**Re: OFFICE OF LONG ISLAND SOUND PROGRAMS  
Notice of Tentative Determination and  
Notice of Coastal Consistency Review  
Application #201005365-MG and FCC #201005371-MG  
Towns of East Lyme and Waterford**

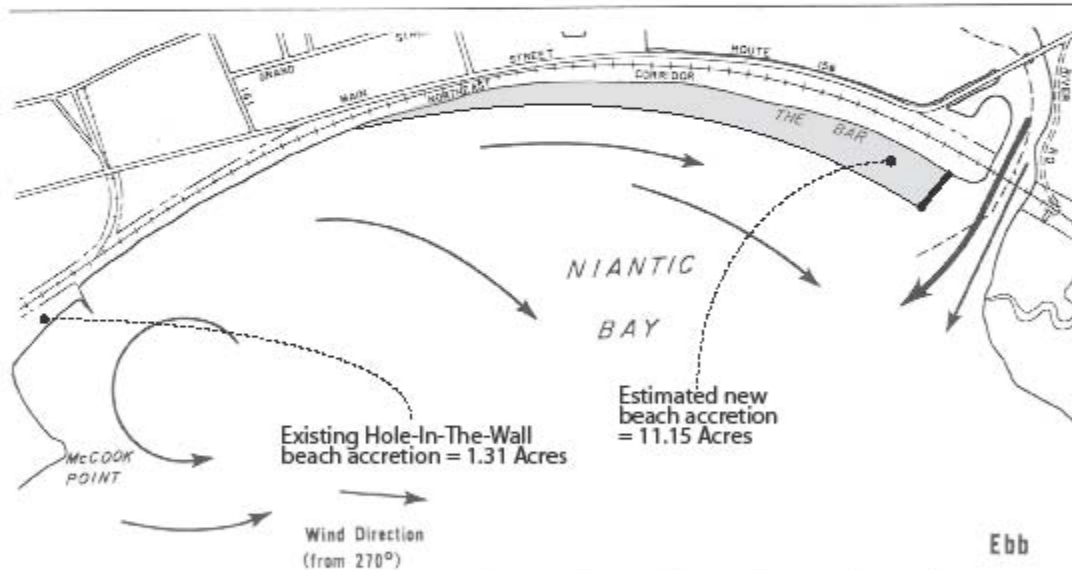
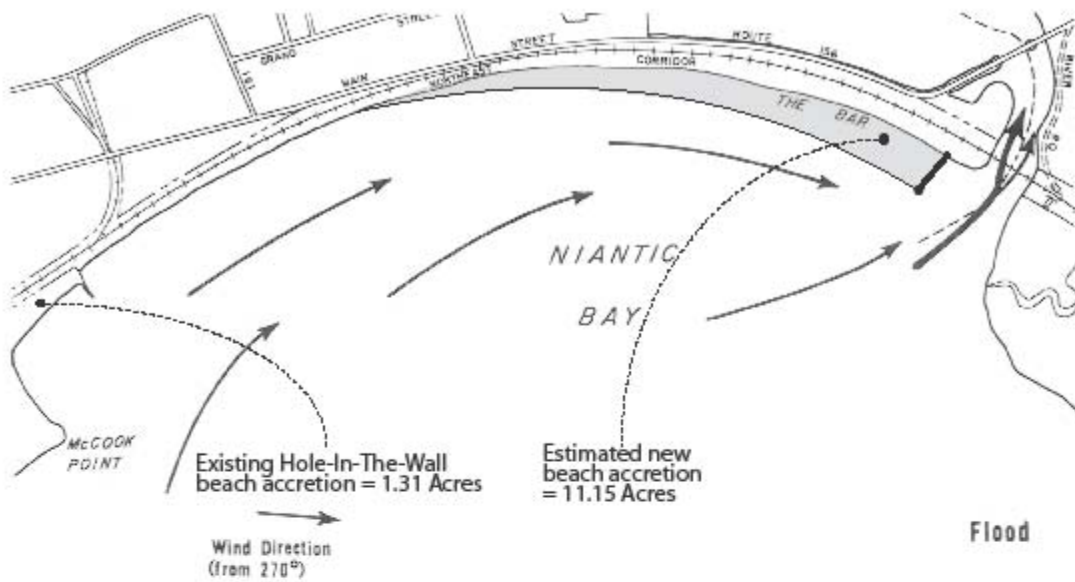
long-shore currents in Niantic Bay were consistently carrying sediments easterly (see Figure 1). Therefore, the proposed groin will function to trap and retain those sediments. Augmentation of that accretion by the addition of 73,000 cubic yards of sand, as specified in the existing permit conditions, is welcome but may not be needed if the project takes advantage of natural accretion resulting from the 2010-2013 storm seasons that will place sand on to the new groin-induced beach. Based on Figure 1 and the proposed groin design, I estimate that an 11.15 acre new beach will be created. The Amtrak request for modification to its Section 401 Clean Water Permit should be immediately approved in order to take full advantage of the 2010-2011 storm seasons. Once the groin is in place, the state, the community, and the Overlook Park will reap substantial benefits in the public trust by the reconstructed Overlook Park and its new beach, thus increasing free public access along the Connecticut coast line to Long Island Sound by approximately 10%.
